TECHNICAL BULLETIN

TB No. AA-05013 REVISION A

NIGHTSUN® SX-16 SEARCHLIGHT

P/N 412-830-101/-200

FIGURE 1 - RECOMMENDED WIRING CONFIGURATION

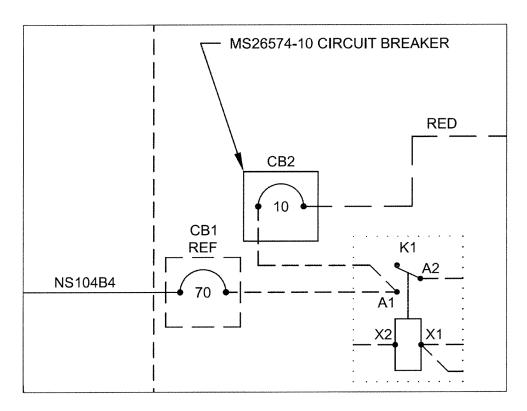
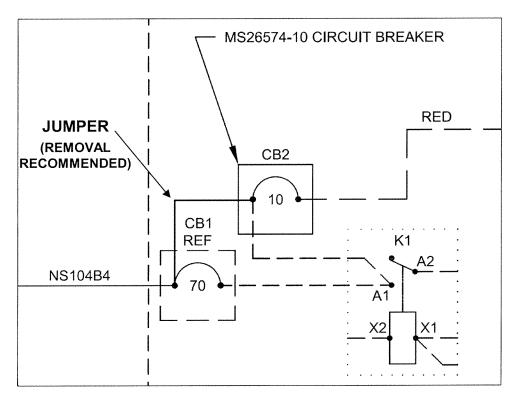
This Technical Bulletin is being issued to advise the operator of a one time modification that may be made to

Main Junction Box Circuit Breaker wiring, potentially

- 1. Ground aircraft and ensure battery master switch is OFF prior to beginning modification.
- 2. Gain access to Main Junction Box. Verify CB2 (see Figure 1) is (MS26574-10) 10 amp circuit breaker. If necessary, replace circuit breaker and wire per Figure 1.
- 3. Inspect wiring of CB1 and CB2. If CB1 and CB2 are jumpered (as shown in Figure 2), remove jumper per Figure 1.
- 4. Modification accomplished.
- 5. Set battery master switch to ON to reapply power to aircraft.
